City of Portland, Oregon
Bureau of Development Services
Land Use Services

NOTICE OF A TYPE II DECISION ON A PROPOSAL IN YOUR NEIGHBORHOOD

CASE FILE NUMBER: LU 12-154498 DZ AD – DYNALECTRIC CONTAINERS & EXTERIOR STORAGE

CASE NO. W 12-154498 02 AD
EXHIBIT C.1

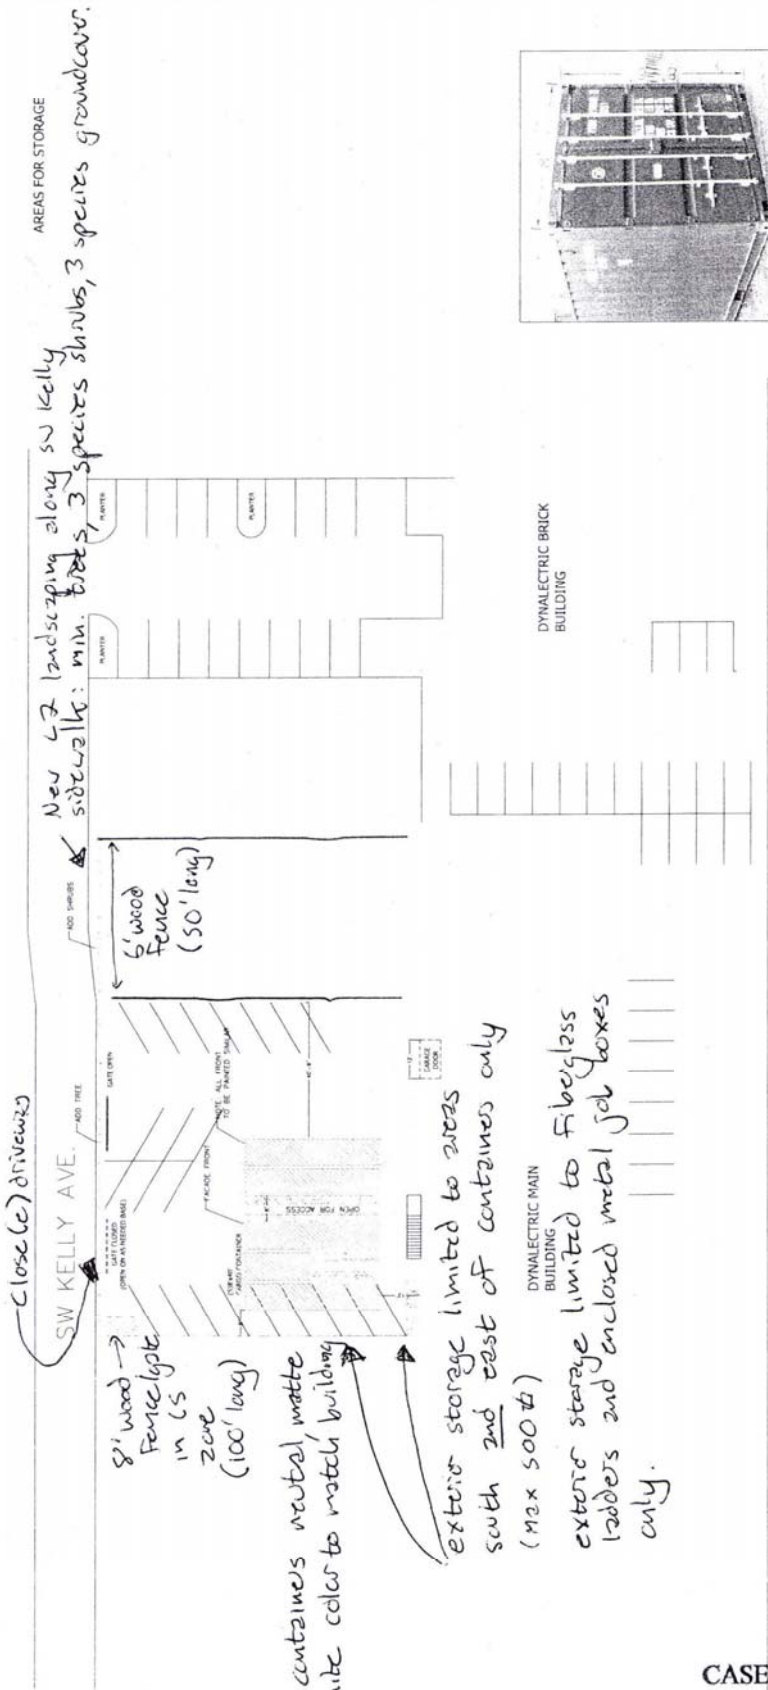
Handwritten note: New (2) landscaping along SW Kelly sidewalk: min. trees, 3 species shrubs, 3 species groundcover.

Handwritten note: 8' wood Fence lgpt. in (5 zone (100' long)

Handwritten note: paint containers neutral, matte off-white color to match building

Handwritten note: exterior storage limited to areas south and east of containers only (max 500 sq ft)

Handwritten note: exterior storage limited to fiberglass ladders and enclosed metal job boxes only.

- B. All visible exterior portions of the five storage containers must be painted a neutral, matte, off-white color to match the adjacent building wall on the Dynalectric building to the east.

- D. The existing slatted chain link fence abutting SW Kelly Avenue shall be removed and be replaced by a 100% sight-obscuring wooden fence and driveway gate. The new fencing and driveway gate must be 8'-0" tall along the 100' of frontage on the CS-zoned portion of the site adjacent to the parking/storage area, and 6'-0" tall along the 50' of frontage on the CM-zoned portion. The fence shall be completed with a flush, finished wood appearance on the street side, with fence posts and horizontal members contained on the interior side of the fence.

- E. The 150'-0" length of property frontage along SW Kelly Avenue shall be provided with new perimeter landscaping immediately adjacent to the SW Kelly lot line, at least 5'-0" deep, and installed at least to the L2 standard of Chapter 33.248. Landscaping shall be provided in the area formerly occupied by the southerly driveway to be removed per condition C, above. All landscaping must be maintained over time. In addition to trees, the applicant shall provide at least three different shrub species, and at least three different groundcover materials in the landscaped area. The applicant is encouraged, but not required, to seek professional design assistance for the fencing and landscaping per this condition, and to consider using native plants from the Portland Plant List.

- F. Exterior storage areas shall be limited to a maximum of 500 square feet, and must be confined to either the south or east side of the containers, as opposed to the locations shown on the submitted site plan.

- G. Exterior storage materials are limited to fiberglass ladders and enclosed metal job boxes only. Storage of fuels, solvents, recycled wooden pallets, scrap metal, and other items are not allowed.
